Product Change Notification

PCN NUMBER : PCN082
Product Category : Solid State Relays – Design Change
Issue Date : 17-May-2019
Effective Date : 17-May-2019
Reason for change : Changes made to improve the production efficiency and the product quality. The Performance of the Products is not affected.
Description of change : Base removed from the bottom of the relays. See images below.
Change to Form Fit Function : Change to Fit. There is no change to form or function.
Parts Affected :

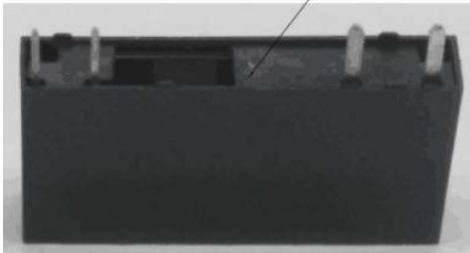
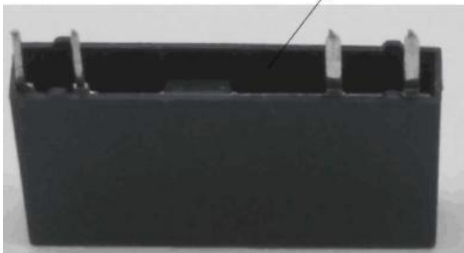
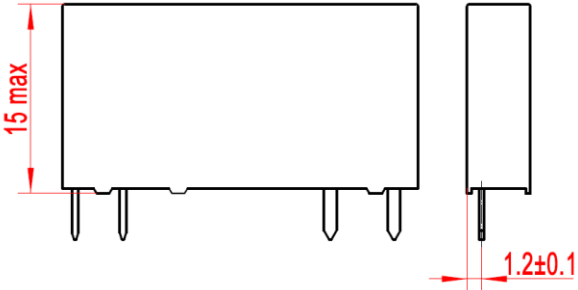
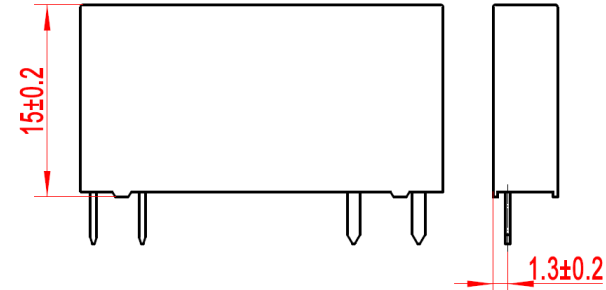
Before Change	After Change
Base	<p>With a base</p> 	<p>Without a base</p> 
Dimension	<p>Height: 15mm max; the distance from the pin to the cover is (1.2 ± 0.1)mm</p> 	<p>Height: (15 ± 0.2)mm; the distance from the pin to the cover is (1.3 ± 0.2)mm</p>
